TO:	Ron Thompson VanMar Engineering
FROM:	Jeff Williams Program Supervisor, Well & Septic Program
RE:	12031 Scaggsville Road perc test plan
DATE:	April 18, 2019

PERCOLATION TEST PLAN

12031 SCAGGSVILLE ROAD

KNIGHT PROPERTY L. 18591 F. 256 FIFTH ELECTION DISTRICT

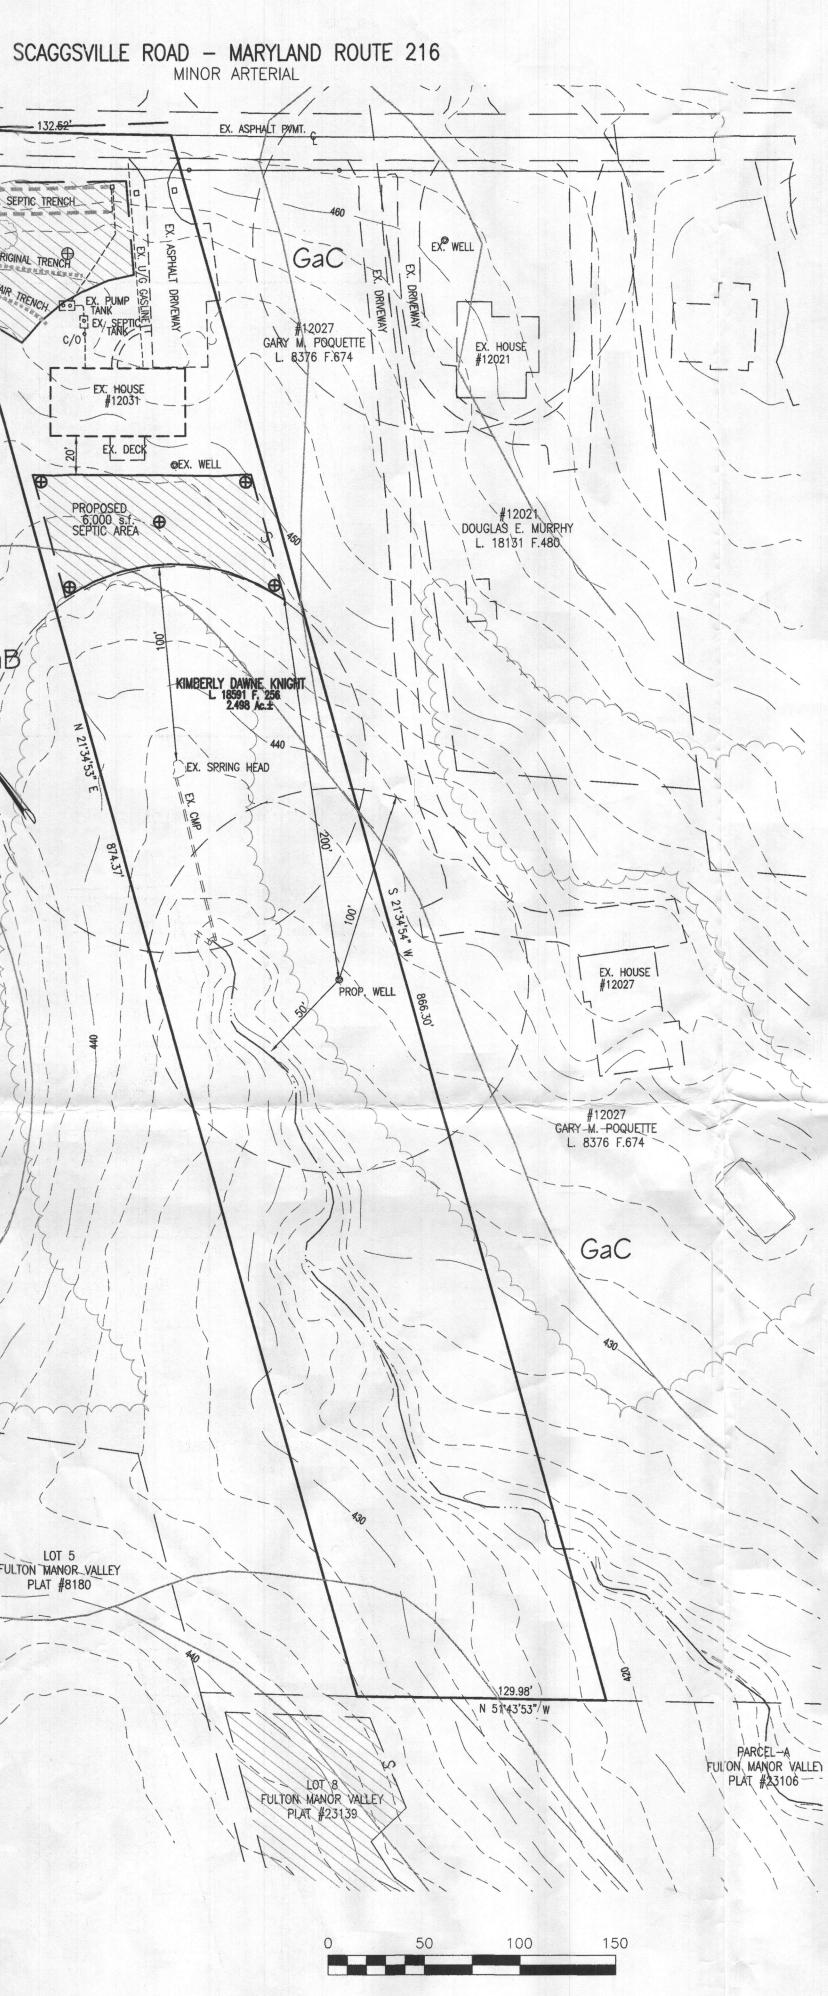
I have reviewed the perc cert submitted electronically on 4/17/2019 and have the following comments:

- 1. The upper test area near the existing trenches is not showing the two older failed drainfields in that area between the new trenches and the house. See the attached health Department file with the repair system as-built diagram from 1981. Once we know where those older systems are located, we can get a better idea of whether there is any room available in the front yard for a future system. We cannot install any future trenches over the old trenches. It is possible that the location of the older trenches eliminates any possibility of fitting a system in the front yard.

- 2. If we are able to test in the front yard, we will not need test holes in the upper corners near the road and the existing trenches.
- 3. Did you field locate the stream in the rear yard? Your plan indicates the stream starting almost 700' from the front property line. However, the perc certification plan for adjacent Fulton Manor Valley (attached) shows it starting around 400' from the front property line. They may not have field located the origin of the stream for that plan, but the Howard County GIS map (attached) shows it starting on the neighboring property 12037 Scaggsville less than 200' from the front property line. Obviously, the stream location will be a major determining factor on where any sewage disposal area can be located in the rear yard as it will need to be at least 100' from the stream. If the stream is located as it is shown on GIS, the majority of the area you show on the test plan is not suitable. A small area near the location of the existing well may be possible, but I'm not sure if it would be large enough to place a system there. Similarly, there is a small area in the rear corner that is outside the 100' setback, but it is so small it does not seem to be useful.

Hi Ron. I'm wondering what your field people discovered with the stream. Dana will be handling this perc if we get to that point. Looking at the test plan, If the stream does start down lower, we will likely look to shift some test holes up into the well arc. The holes on the lower left side do not establish an area suitable for sewage disposal with the swale starting on the 440 and 438 contours. We would look to be more on the south side (right side) of that feature.

Ron, did you field locate the old trench locations? It doesn't look like there is room to fit a replacement system between where you are showing the original trench and the new trenches. If the original trench is any closer, then it would be even worse. We have a perc hole from the repair right in that space downhill from the new trench. We would need two holes on either side down closer to the tank if we were going to pursue that area, but not until we know there is even room to do anything in there.

Did you field locate the start of that stream relative to the rear yard test area?

Jeff: Attached is the updated Percolation Test Plan. The survey field crew will be locating the septic areas, test pits and beginning of the stream today.
